LOCAL HISTORIC DISTRICT: Plaza Midwood

PROPERTY ADDRESS: 1414 The Plaza

SUMMARY OF REQUEST: Alternate material

Charlotte Historic District Commission Case 2017-272
HISTORIC DISTRICT: Plaza Midwood
SUBSTITUTE MATERIAL

4 BACK ELEVATION
1/4" = 1'-0"

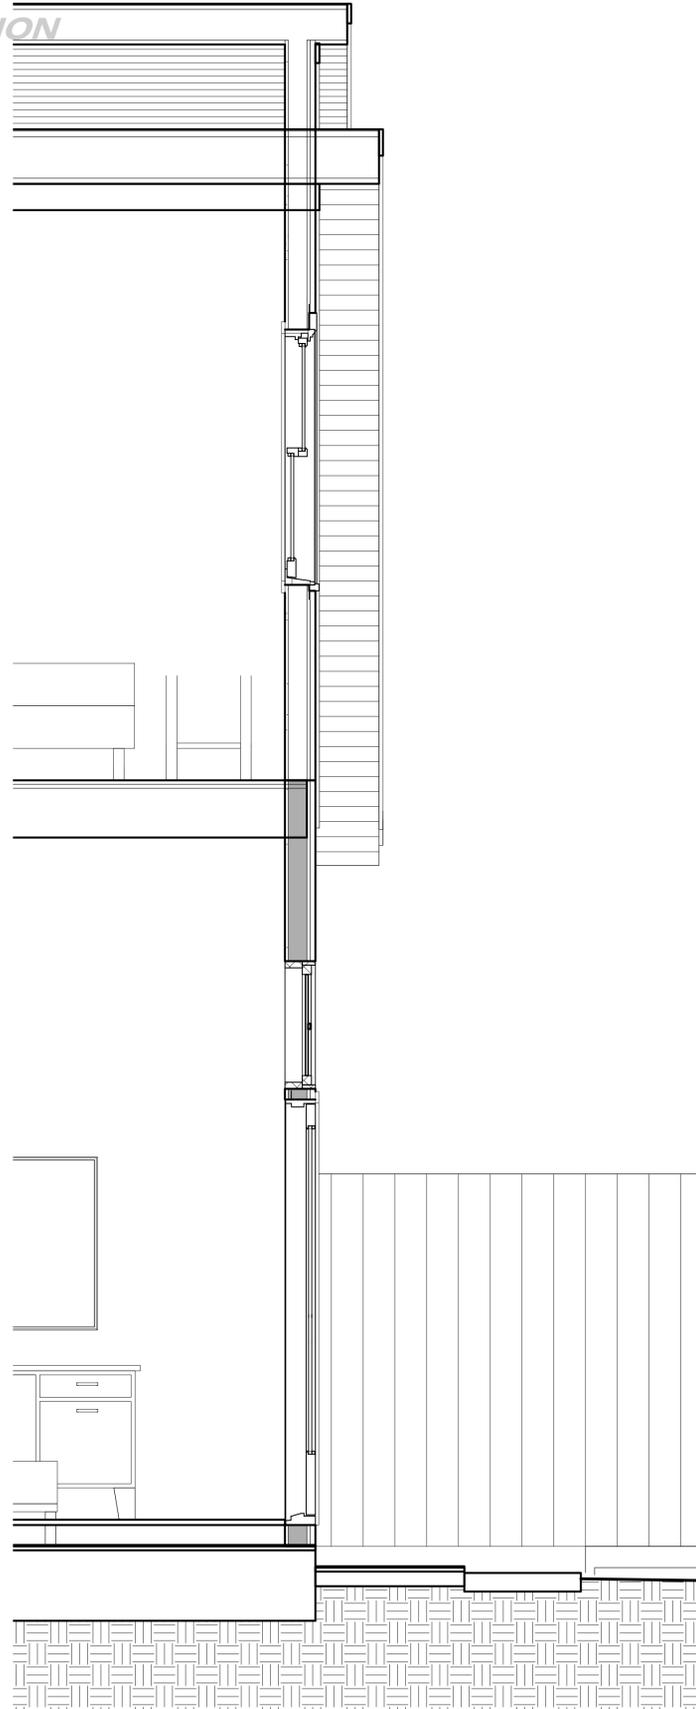
The applicant is requesting the use of Hardie Artisan siding on the rear addition with mitered corners as shown on the plans.

Staff Analysis - The Commission will determine if the siding material is appropriate for the main structure.
